SUNDRY NOTICES AND REPORTS ON WELLS (DO NOT USE THIS FORM FOR PROPOSALS TO DRILL OR TO DEEPEN OR PLUG BACK TO A DIFFERENT RESERVOIR. USE "APPLICATION FOR PERMIT" (FORM C-101) FOR SUCH PROPOSALS.)		WELL API NO. 30-045-09671

2. Name of Operator HILCORP ENERGY COMPANY		6. State Oil & Gas Lease No.
3. Address of Operator 382 Road 3100, Aztec, NM 87410		7. Lease Name or Unit Agreement Name Sam Cooley

SR RC Wellbore Prep/csg leak

Well Name: SAM COOLEY #1

Current Schematic - Version 3

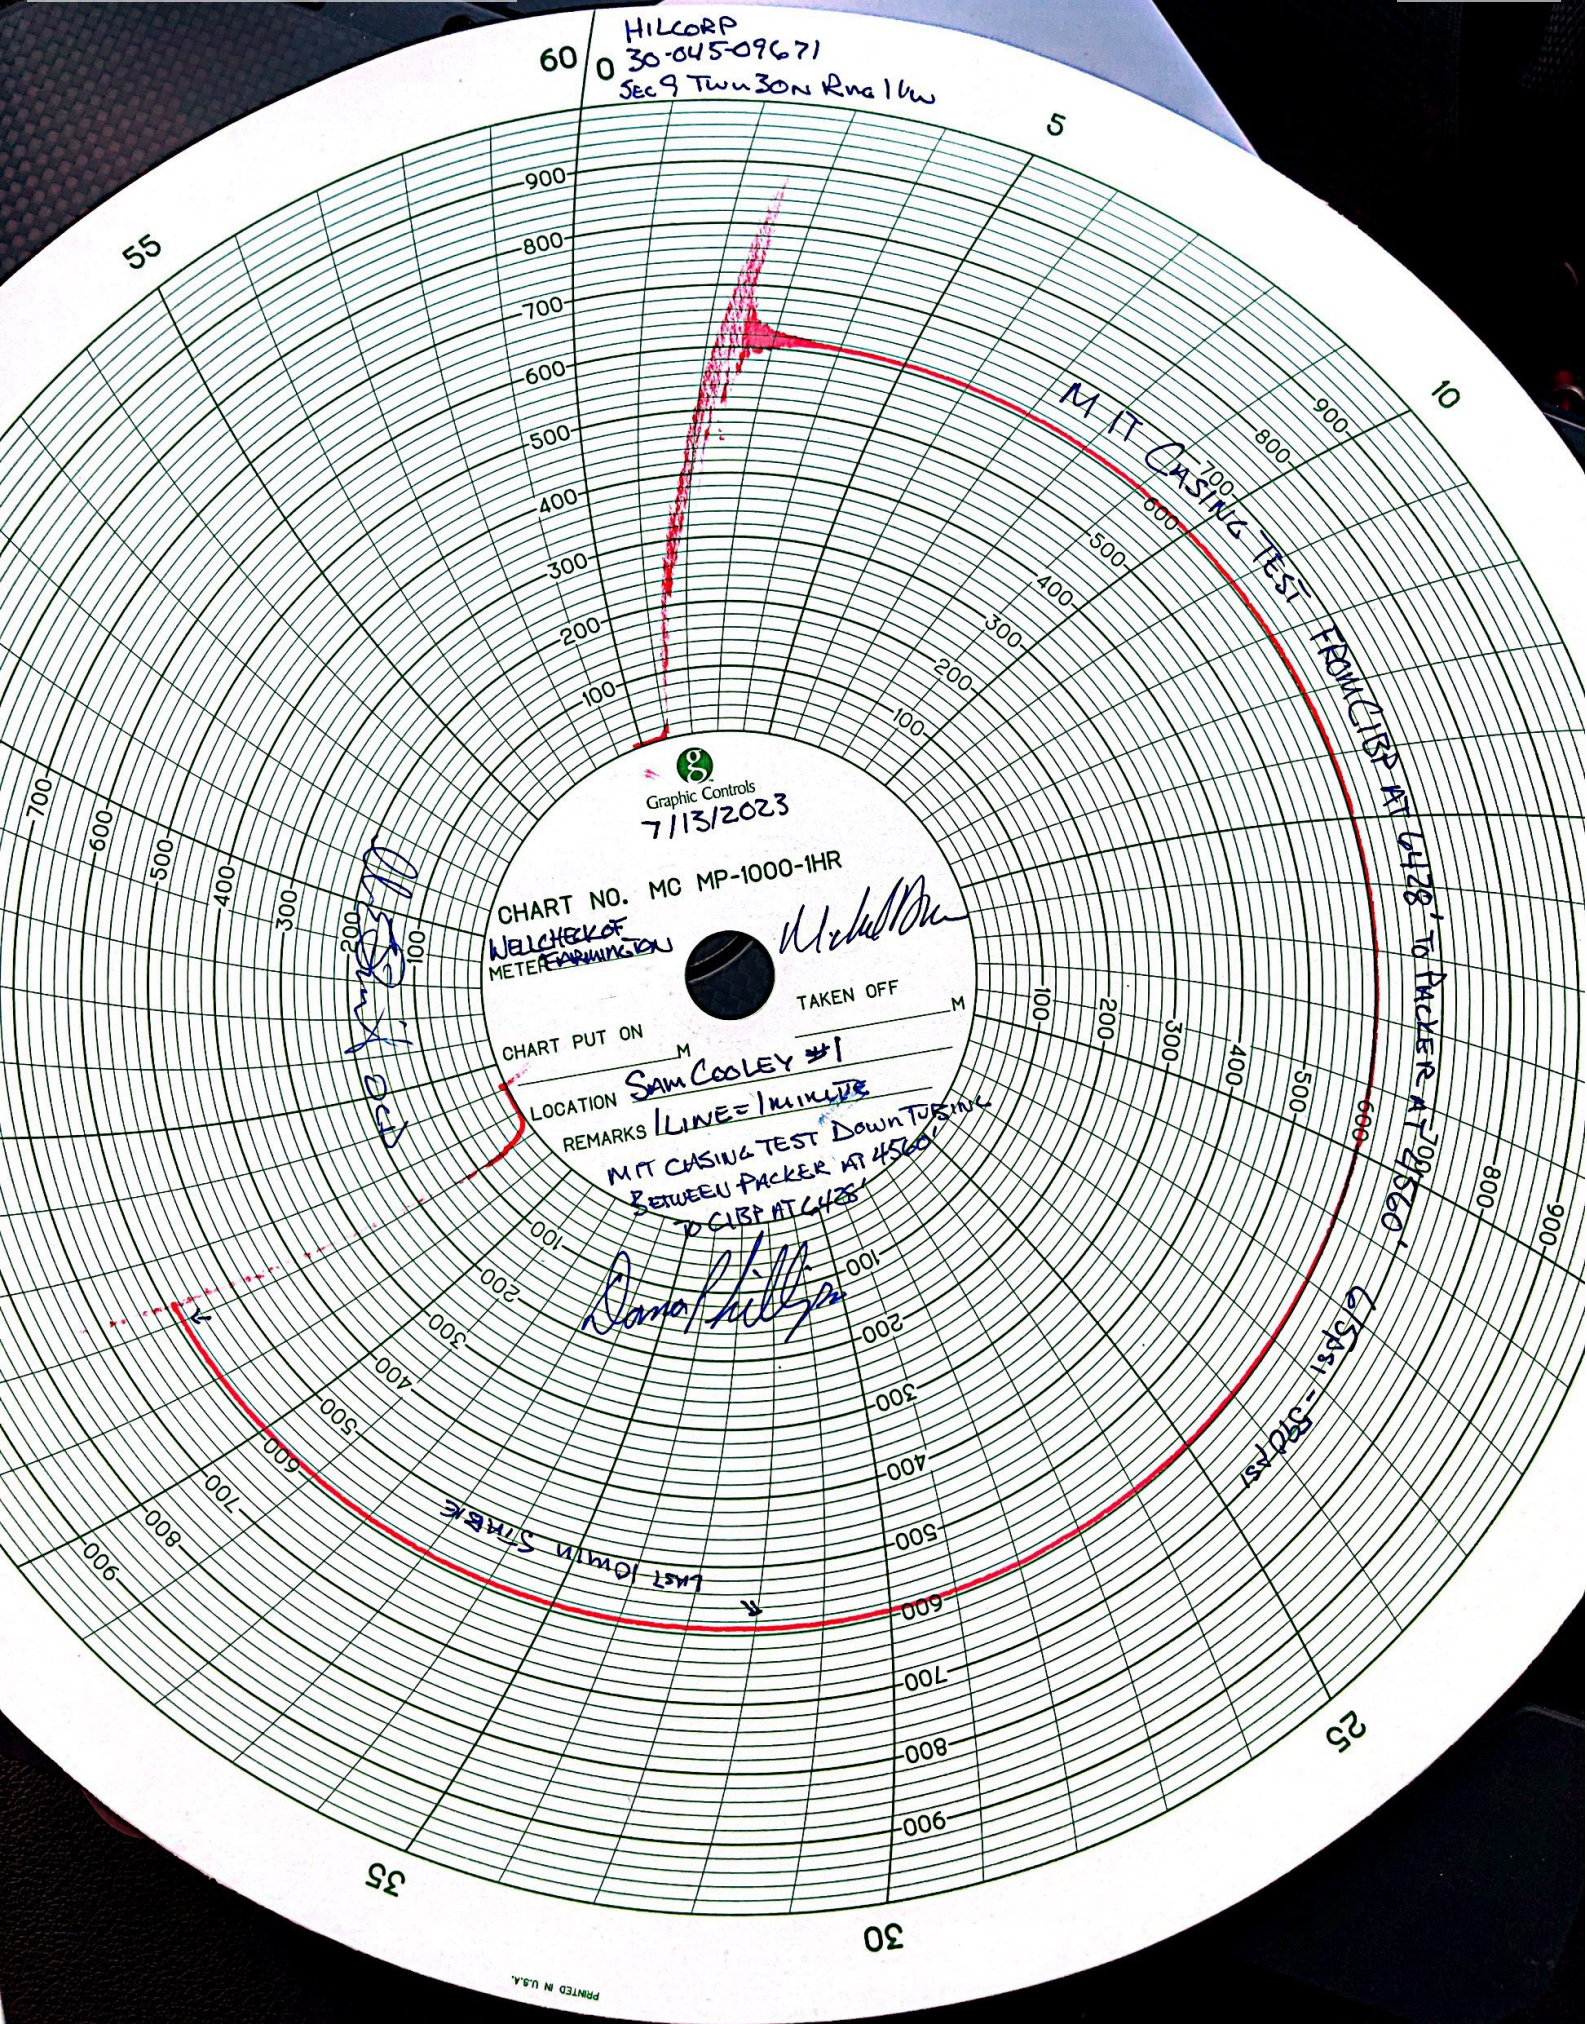
Monica – per our verbal conversation, we will proceed with cement remediation by pumping a 515' balanced plug across the leaking interval (from 3759'-4274').

The distance between the top of the Gallup and the bottom of the Mesaverde is 1023'. Current schematic is attached for reference.

NMOCD approves balanced plug across leaking interval from 3759-4274

Please include schematic and email chain in subsequent.
